Subject: CERTIFICATE OF COMPLIANCE NO. 9292 FOR THE MODEL NO. PATRIOT
PACKAGE: Submission of Revision 3 to the Safety Analysis Report (SAR)

Enclosure 1: Patriot SAR Revision 3 Change Pages

Application for Certificate of Compliance for the Patriot BWR Fuel Shipping Package

USA/9292/AF-85

DATE	BY	CHKD	APP'D	DESCRIPTION
03/26/14	J. HALLIGAN			OPTIONAL PATRIOT BVR INNER SHIPPING PACKAGE AND SAFETY ITEMS
01				10015E58

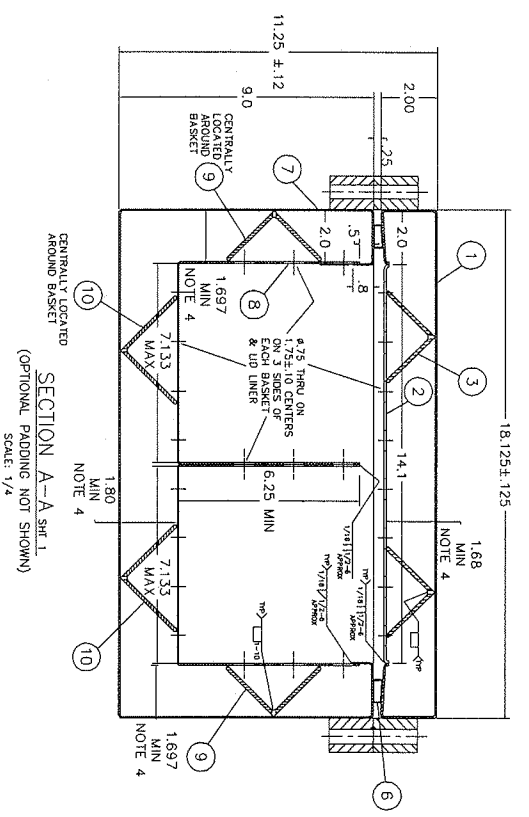
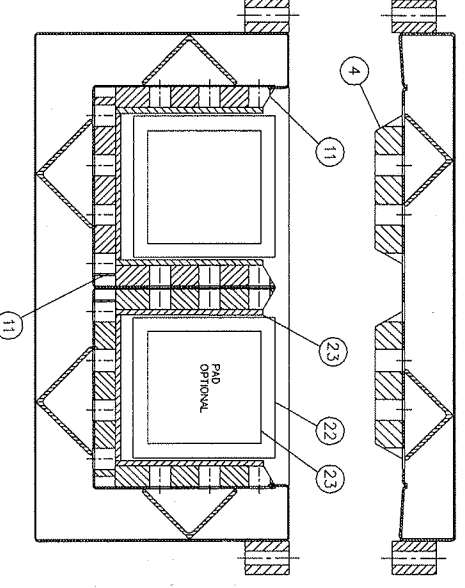
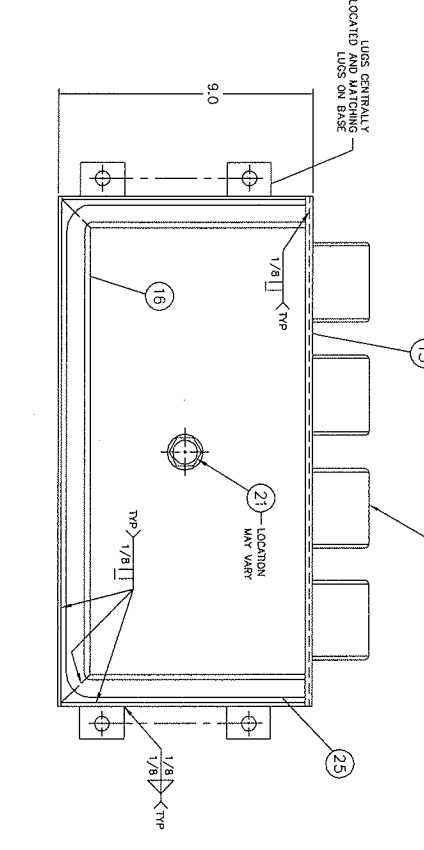
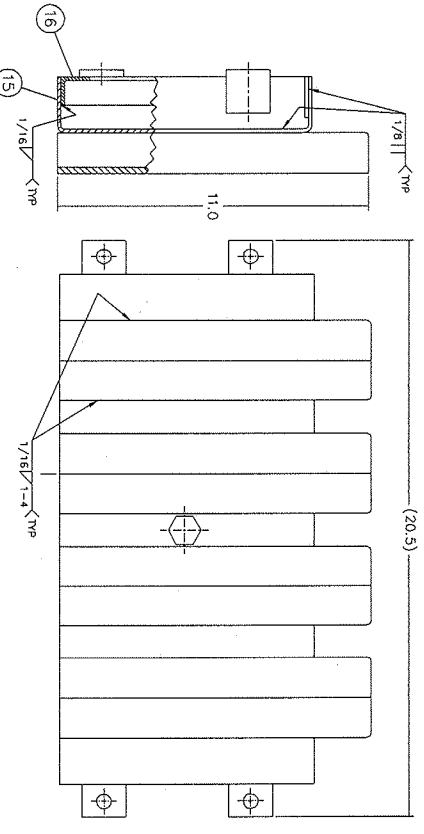
Page 1A-1: Revised sentence describing the license drawings to include drawing #10015E58, Optional Patriot Inner Container. This drawing is identical to License drawing #L-9272-01 from the CE-B1 SAR.

Added new License Drawing 10015E58, Optional Patriot Inner Container.

Add the following line:

10015E58, Sheets 1 and 2, Rev. 1
